NOKIA MOBILE PHONES, Inc.
12278 Scripps Summit Drive
San Diego, CA 92131
Tel (858) 831 5000

Attention: FCC Application Processing Branch
RE: FCC ID: GMLNSD-1AW
731 Confirmation number EA96445
Correspondence reference number: 15017

Reply to Correspondence Reference Number 15017 questions

Meas 1

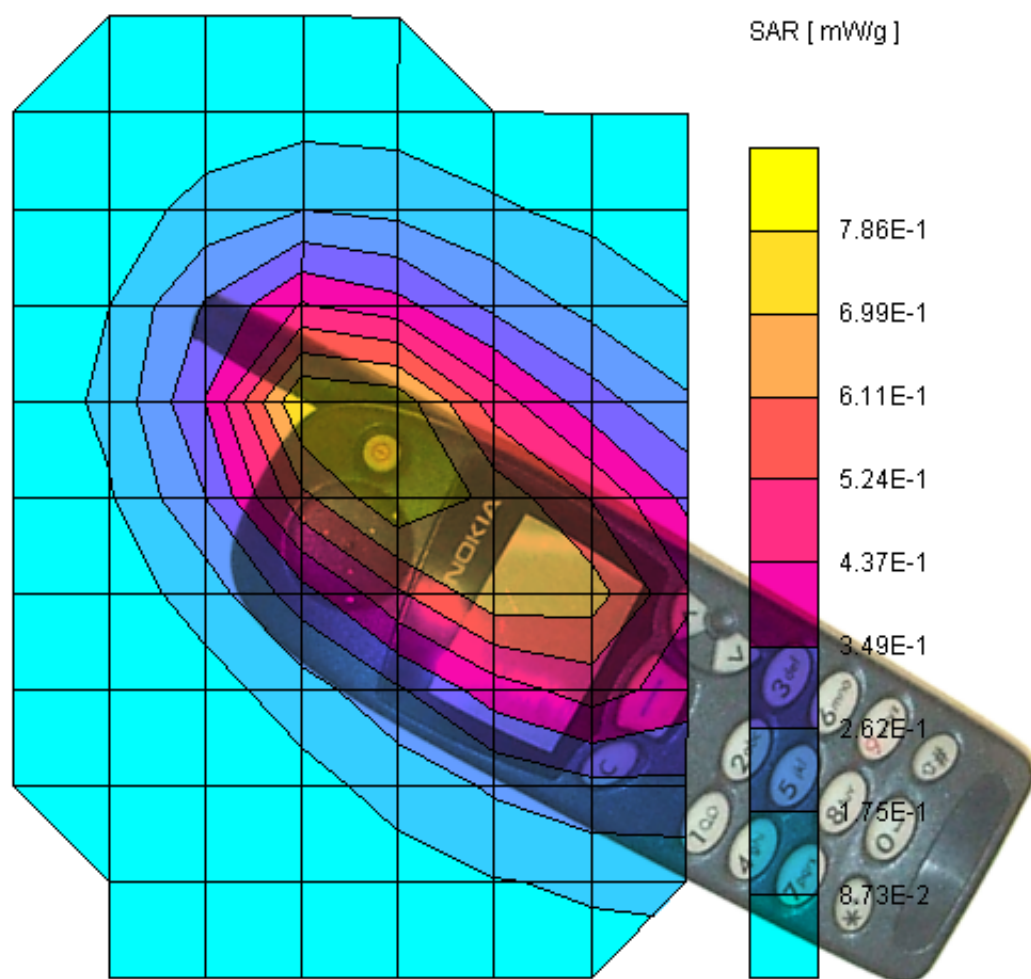
Question 2. The re-measured output for AMPS is higher than previously measured, but SAR tests were not done at the higher output level. The output indicated in the SAR report and those in the original EMC data for AMPS mode have about 0.9 dB variation across the band. The latest output results do not have such variations and what used to be the channel with the lowest output corresponds to the channel with the highest output in the latest data. Some performance changes appear to have occurred in the latest version of this device and it is not even clear if the original SAR results are still applicable. Furthermore, the applicant is scaling this SAR data to justify up to 1.8 dB increase in output, about 50% increase. The SAR data neither supports the latest output power measurements nor the increase in output. It is also not clear if any changes that might have occurred could also affect SAR for the PCS band. Please clarify these discrepancies and retest SAR as necessary.

The device allows power adjustment separately on 5 channels of the band. When decision about higher power level was made, it was also decided to adjust every point separately as indicated in originally attached tuning instructions. So the scaling to the 26.5dBm level on the three channels is correct and consistent with the current tuning procedure. Please find test data attached for additional evaluation.

SAR (1g): 0.762 [mW/g] SAR (10g): 0.514 [mW/g]
